Final Environmental Impact Report (Final EIR)

Los Angeles International Airport (LAX) Northside Plan Update

Responses to Comments and Corrections and Additions to the Draft EIR

December 2014

The DEIR Fails to Identify, and Thus Fails to Analyze Potential Impacts on, Most Existing and Proposed Bikeways in the Vicinity of the Project

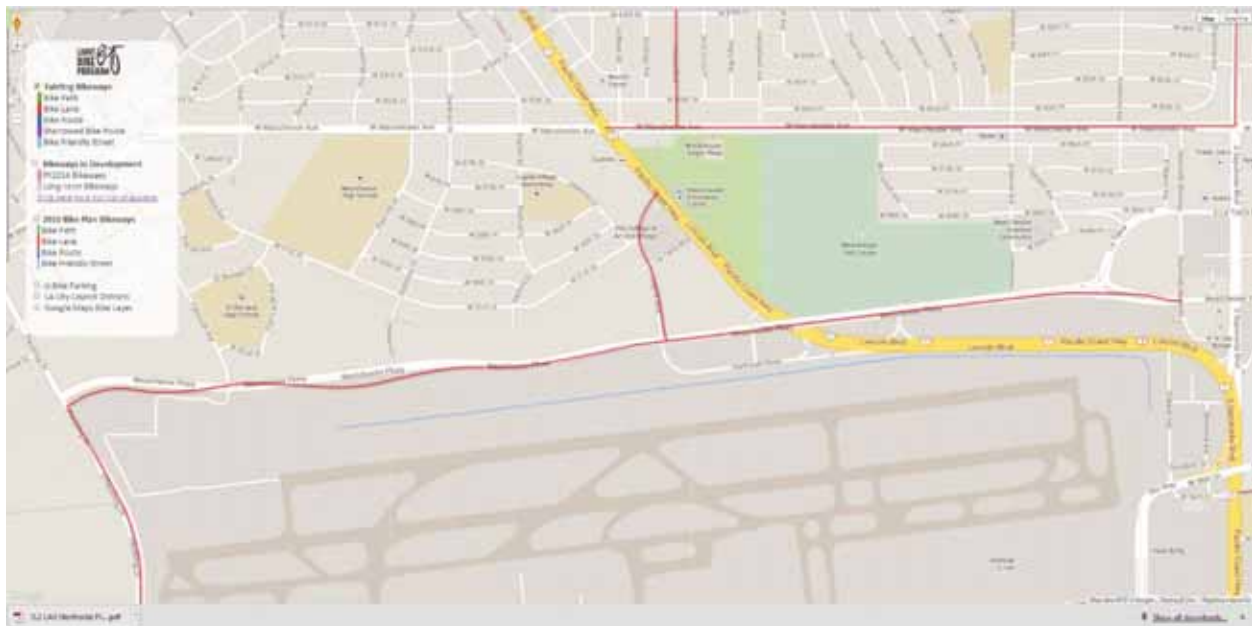
To determine whether the Project conflicts with the 2010 Bike Plan regarding bicycle facilities, the DEIR must first correctly identify the existing and proposed bikeways¹ in applicable plans.² Because the DEIR does not do so, its analysis is by definition inadequate. Quite simply, the DEIR cannot evaluate impacts on bikeway projects that it does not acknowledge even exist.

The DEIR ignores most of the existing or potential on-street bikeways in the immediate vicinity of the project. According to the DEIR, “there are currently dedicated bicycle lane on Westchester Parkway and Pershing Drive adjacent to the Project Site.” The map below, from the LADOT Bicycle Program website, <http://www.bicyclela.org>, shows that there are also existing bike lanes on Manchester Avenue and Loyola Drive adjacent to the Project Site.
